Access Compliance Report

Public Rights-of-Way

(Curb Ramps)

Intersection ID: 4249	Main Street: N_TRYON_ST	Cross Street: PAVILION_BV	Location: NE
ADA ID: 3A6EBB501519	Ramp Type: Perp	Initial Pass/Fail: Pass	Overall Compliance: No
Codes/Mitigation Info/Possible Solution			Severity Score: 2.5
			Field Measurements/Component Compliance

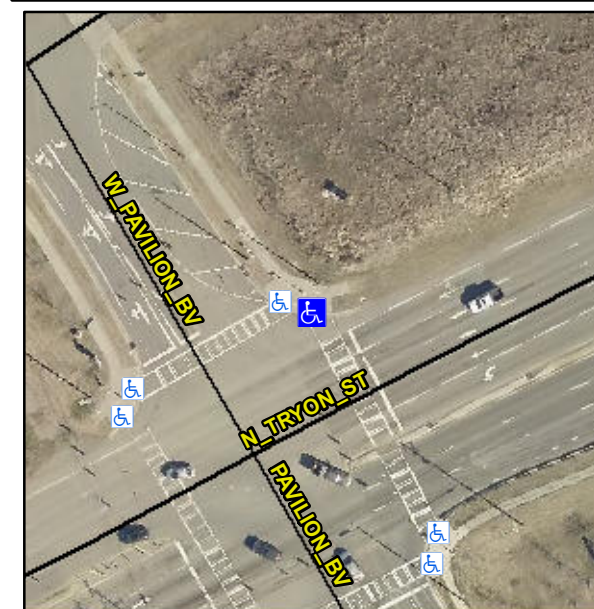
R305.1.4

Remove & Replace Detectable Warning System.
